U.S. NUCLEAR REGULATORY COMMISSION

Report No: 50-305/99010(DRP)

Facility: Kewaunee Nuclear Power Plant

Kewaunee Nuclear Power Plant NRC Inspection Report 50-305/99010(DRP)

Simplified Drawing

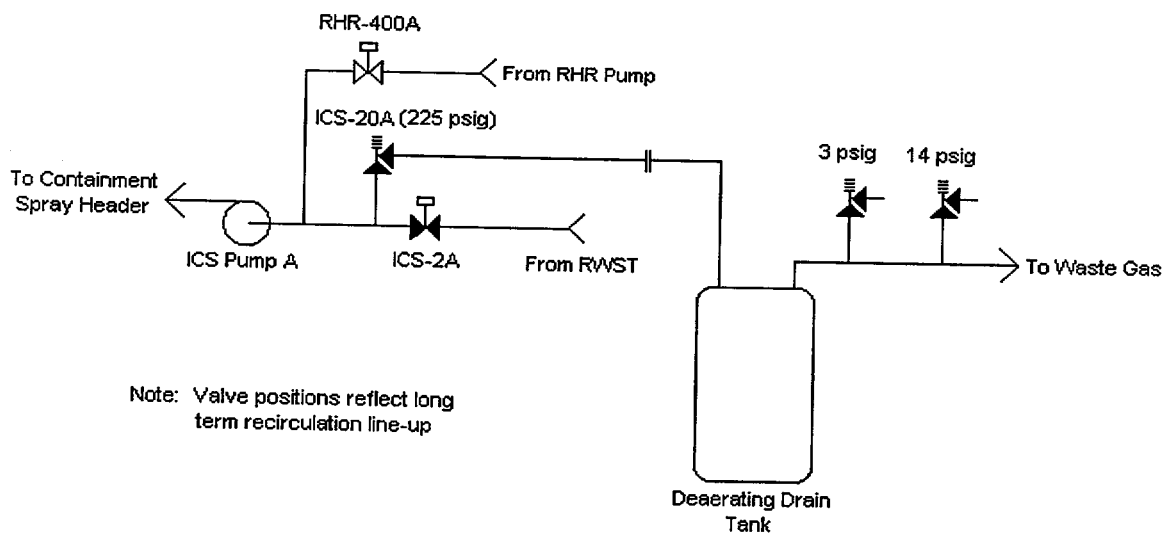
During the observations of the SP, the inspectors noted that the boric acid residue on a coupling downstream of the relief path for relief Valve ICS-20A could be indicative of premature valve lifting or weepage past the valve. This was discussed with licensee personnel for evaluation. Operation personnel had also previously identified the boric acid residue as a recurring condition and were tracking this condition in the Boric Acid Leak Tracking Log. The relief valve was located on the suction piping of ICS Pump A, as shown on the simplified system drawing below:

Additionally, the inspectors questioned licensee personnel regarding the relief valve setpoint. During normal plant operations, the system pressure at the relief valve is the nominal Refueling Water Storage Tank pressure of 25-30 pounds per square inch gage (psig). During the performance of Procedure SP 34-099, the pressure at the relief valve is approximately 180 psig due to the residual heat removal pump providing the supply to the ICS pump, as in the long-term recirculation mode of operation. The relief valve discharge was routed to the deaerating drain tank, which could be potentially pressurized up to 14 psig. The inspectors questioned the licensee as to whether the drain tank back-pressure had been accounted for in the setpoint determination for the relief valves in each ICS train (Valves ICS-20A/B). This was of concern since the relief valve setpoint was set at 225 psig and the ICS pump suction piping design pressure was also 225 psig, as discussed in USAR Section 6.4.2.

The above issue will be documented as an Unresolved Item (URI) pending further NRC review of the licensee's evaluations of whether the failure to include the back-pressure in the setpoint determination of Valves ICS-20A/B constituted a violation of the licensee's In-Service Test plan (URI 50-305/99010-02, Effect of Back-pressure in the Determination of ICS Relief Valve Setpoint).

The licensee initiated KAP 3480 to document the inspectors concerns. The licensee's prompt operability determination in KAP 3480 was that Valve ICS-20A was operable based on satisfactory leak tests which had been previously performed. Additionally, premature lifting of the relief valve was unlikely based on insignificant changes in drain tank levels logged prior to and following the performance of Procedure SP 34-099. However, the licensee acknowledged that weepage past the valve could occur and that continued evaluation was necessary. The inspectors did not identify any deficiencies with the licensee's operability determination. With respect to the relief valve setpoint, the licensee determined that the drain tank back-pressure had not been accounted for in the determination of the relief setpoint of Valve ICS-20A, but that pipe stress limits would not be exceeded if the relief valve lifted at a higher pressure than 225 psig.
